Project		Design and Construction of Civil and Buildings Works including Testing and Commissioning on Design-Build Lump Sum Price basis for Double Line High Speed Railway for Mumbai Underground Station, Cut & Cover Tunnel and Shaft -1 from MAHSR Km. -0.255 to Km. 0.775 at Bandra-Kurla Complex in the State of Maharashtra for the Project for Construction of Mumbai-Ahmedabad High Speed Rail			
Package No.		MAHSR - C - 1

Response to Bid Queries (Set-3) - 30.04.2020					
S No	Part & Section Reference	Page No / Clause No.	Provision as per Bidding Documents / Subject / Title / Item as mentioned by the Bidder	Bidder Query	Employer's Response
1	Part-1, Section-II, BDS (Vol.1 of 2)	BDS Clause No. ITB-24.1 Page 3 of 34 (16/632)	Last Date for Submission of Tender: The deadline for Bid submission is: Date : 19.03.2020 Time : 15:00 hrs	The Bidder to collect various information for planning for project logistics, material availability and so on, prior to preparation of bid, which required substantial time. Further Bidder requires to depute designer and MEP specialist agency to perform the pretender design works which required a substantial time for competitive bidding. In view of the above bidder

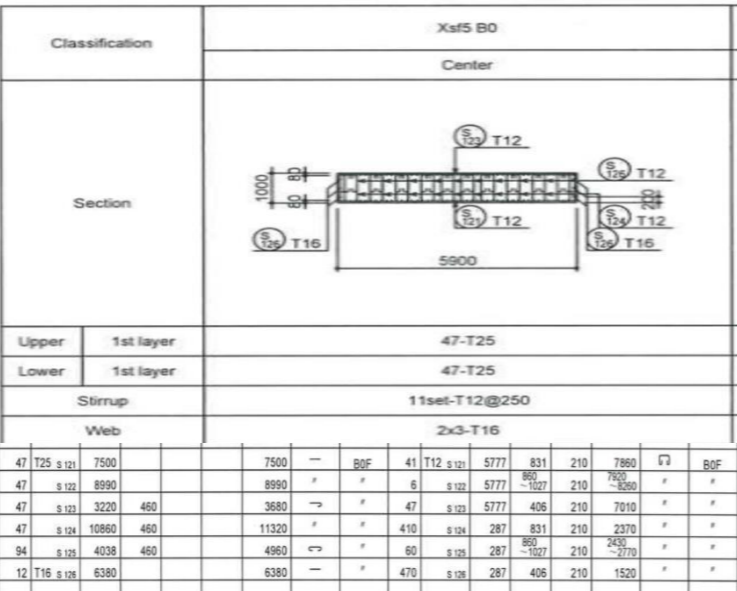
20	Section VI-4, Architectural Drawings	B0-JIC-C14-DRW-S01-STA-NTU-04001-000	Detail Section-1	Detail section 1 indicates semispherical Decorative cast aluminum ,where as Division 05010 page no. 46 of 60 depicts these decorative elements in the form of cone of 500 mm dia and 150 mm height. Please provide the detail drawing of these decorative cast aluminum along with its fixing details on concrete panels.	Refer BD-JIC-C14-DRW-S01-STA-NTU-4001 to 4003 & 06111. The Contractor shall develop during detailed design for the approval of the Engineer.
21	Section VI-4, Architectural Drawings	B0-JIC-C14-DRW-S01-STA-NTU-04001-000	Detail Section-1	Please provide top and bottom fixing details for the column structural mild steel	The Contractor shall develop during detailed design for the approval of the Engineer.
22	Section VI-4, Architectural Drawings		General	The details for at grade landscape is not shown. Please provide details.	The scope of Landscaping is shown in BD-JIC-C14-DRW-S01-STA-NTU-01101, 02108, 02201, 02202, 02203, 02204, 04011 and 06104. The Contractor shall develop during detailed design for the approval of the Engineer.

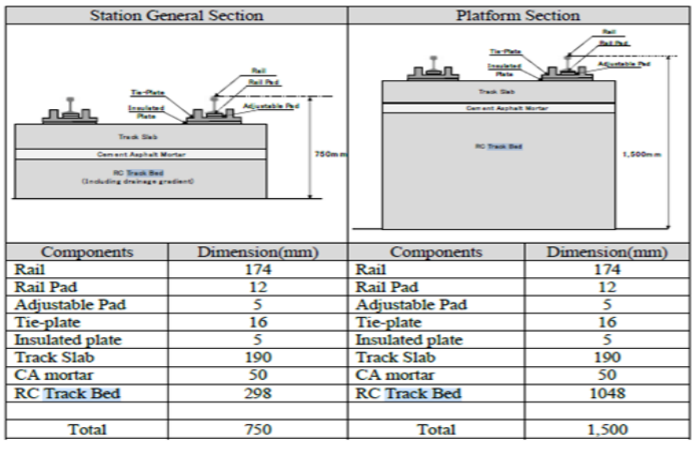
S No	Part & Section Reference	Page No / Clause No.	Provision as per Bidding Documents / Subject / Title / Item as mentioned by the Bidder	Bidder Query	Employer's Response						
62	Volume – 2 of 2, Section VI-2, Employer's Requirement (Design Requirement and criteria) Division 05040	Clause 17.5 Page 34 of 58 Electrical		Please confirm the fault level of DSS & S&T UPS for earth mat design	Refer Sub-Clause 4.4.9 of DRC 05040. The Contractor shall interface with E-1 contractor during the detailed design.						
63	BD-JIC-C14-DRW-S01-STA-NTU-022(01-41)	Architecture		Wall material (AAC block work or RCC) of Staircase enclosure walls at all levels is not consistent in Architecture and structure drawings. Hence, we are considering as RCC wall for the same Please confirm.	Refer Note-3 of Addendum No. 01, Item No. 38.						
64	BD-JIC-C14-DRW-S01-STA-NTU-02201 & 02203	Architecture		In structure drawings RCC Columns are shown from URF level going up to entry structures' roof level (On grids Y2, Y3, Y5 & Y6) inside the Aesthetical MS tubular columns/ elements. Whereas these columns are not shown in Architecture drawings. Please confirm which drawings to be followed Architectural or Structural drawings.	Refer Note-3 of Addendum No. 01, Item No. 38.						
65	BD-JIC-C14-DRW-S01-STA-NTU-021(01-03)	Architecture		Grid Dimensions of Elevation is not matching with Floor Plans. Hence, we are following floor plans. Please confirm.	The grid dimensions mentioned in the Floor plans shall be followed.						
66	Volume 2 of 2, Section VI-4 (DRAWINGS). BD-JIC-C14-DRW-S01-STA-NTU-02112-000 & 02110-000	MUMBAI STATION B1 FLOOR ENLARGED PLAN-2 , ROOF, MF, URF ENLARGED PLANS	Provision of Spiral Staircase No. M5,M6,M7 & M8	Kindly provide Spiral Staircase details. We understand that its construction material is structural steel. Please confirm.	The stairs are only for maintenance personnel. The Contractor shall propose the material and develop the details during detailed design for the approval of the Engineer.						
67	Volume 2 of 2, Section VI-4 (DRAWINGS). BD-JIC-C14-DRW-S01-STA-NTU-02112-000	MUMBAI STATION B1 FLOOR ENLARGED PLAN-2	Provision of Machine hatch	Kindly provide machine hatch size.	Refer Slab Structural Opening Plan (BD-JIC-C14-DRW-S01-STA-NTU-06260 and BD-JIC-C14-DRW-S01-STA-NTU-06267)						
68	Volume 2 of 2, Section VI-4 (DRAWINGS). SD-MTC-D01-TDS-S01-CCT-NTU-20214-001 & SD-MTC-D01-TDS-S01-CCT-NTU-20164-001	RC DETAILS: B1 (SLAB) LVL. SHEET (2 OF 8) and RC DETAILS: CROSS SECTIONS SHEET (3 OF 5)	Provision of Slab Reinforcement.	Mismatch in Slab reinforcement plan and Section drawings

As this mismatch will affect Quantity, Please clarify and confirm the drawing to be followed. Similar mismatch is observed in Cut and Cover portion also.	Top -ve Reinforcement		Plan	Section	Y20 @ 150	Y20 @ 150 and Y20 @ 300 Alternatively	Refer Addendum No. 01, Item No. 41 and Addendum No. 02, Item No. 37.
Top -ve Reinforcement											
Plan	Section										
Y20 @ 150	Y20 @ 150 and Y20 @ 300 Alternatively										
69	Volume 2 of 2, Section VI-4 (DRAWINGS). SD-MTC-D01-TDS-S01-CCT-NTU-20213-001	RC DETAILS: B1 (SLAB) LVL. SHEET (1 OF 8)	Provision of Slab Reinforcement.	Top reinforcement is given as Y20@150+Y16@150. Our understanding is that both above bars are bundled and provided at a spacing of 150 c/c and are curtailed at 3100 from face of the beam. No top reinforcement at mid span. Please confirm.	Refer Addendum No. 01, Item No. 41.						
70	Volume 2 of 2, Section VI-4 (DRAWINGS). BD-JIC-C14-DRW-S01-STA-NTU-07003-000 and 07004-000	MUMBAI STATION ENTRANCE-2 FRAMING PLAN and ELEVATION		1. Member are listed with only outer sizes. Hence, kindly provide member thickness. 2. In plan, all un-named beams are given as SB4 whereas section taken at that location (Section at Y4) are marked as SB2. Please confirm the correctness.	1. Members shown in the drawings are for reference only. The Contractor shall develop during detailed design for the approval of the Engineer. 2. SB4 is correct.
